Roof Curb Service Bulletin - 10-11-2011

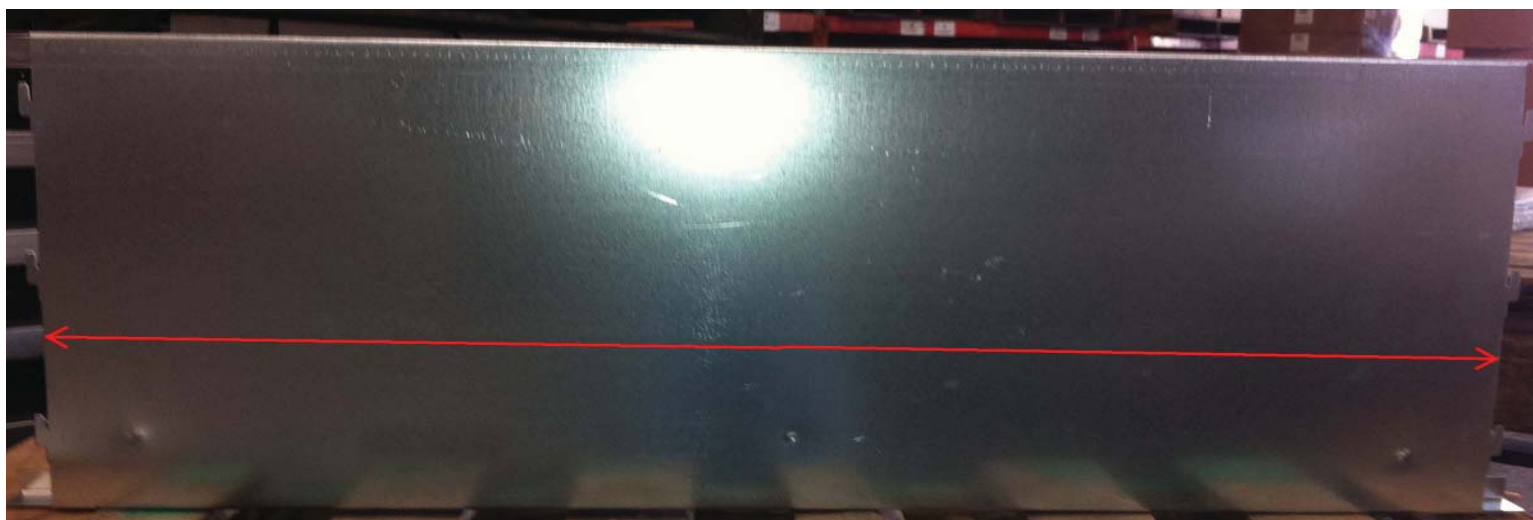
A defect in the two shorter sides for part numbers 14CURB3672B, 14CURB90150, 14CURB180240 and PGC101/102/103 has been detected. Incorrect notching on shorter pieces of the affected parts results in the curbs being approximately ½” larger than specified when assembled. As a result the insulated panels and duct supports do not fit into the curb properly.

On the curb label is a job number (circled below) that may help in determining if current inventory is affected. The photo below depicts the location of the job number and the table that follows identifies the job numbers that are present on the flawed curbs.

A measurement may also be taken in the location depicted in the second photo of the side with the 'hooks' to determine if the part is defective as well. Please see the accompanying table for the correct measurements.

McDaniel Metals is currently in the process of re-manufacturing the narrow sides with proper notching for replacement in the parts where the defect is present. We propose that, rather than cut the bands on the curbs and replacing the defective parts, we build and send correct sides separately that can be included with the entire curb package at the time of sale with explicit instructions to discard the parts included with the curb in favor of the replacement sides. In places where a great deal of defective inventory is present we would send replacement inventory and provide advice on how to return the incorrect parts to McDaniel Metals at our expense.

*The inside dimension of the part should equal the dimension in the **Correct** column below.

Item Number	Incorrect	Correct
14CURB3672B	37 3/8	37
14CURB90150	50 3/8	50
14CURB180240	75 1/8	74 3/4
PGC101/102/103	39 3/4	39 3/8
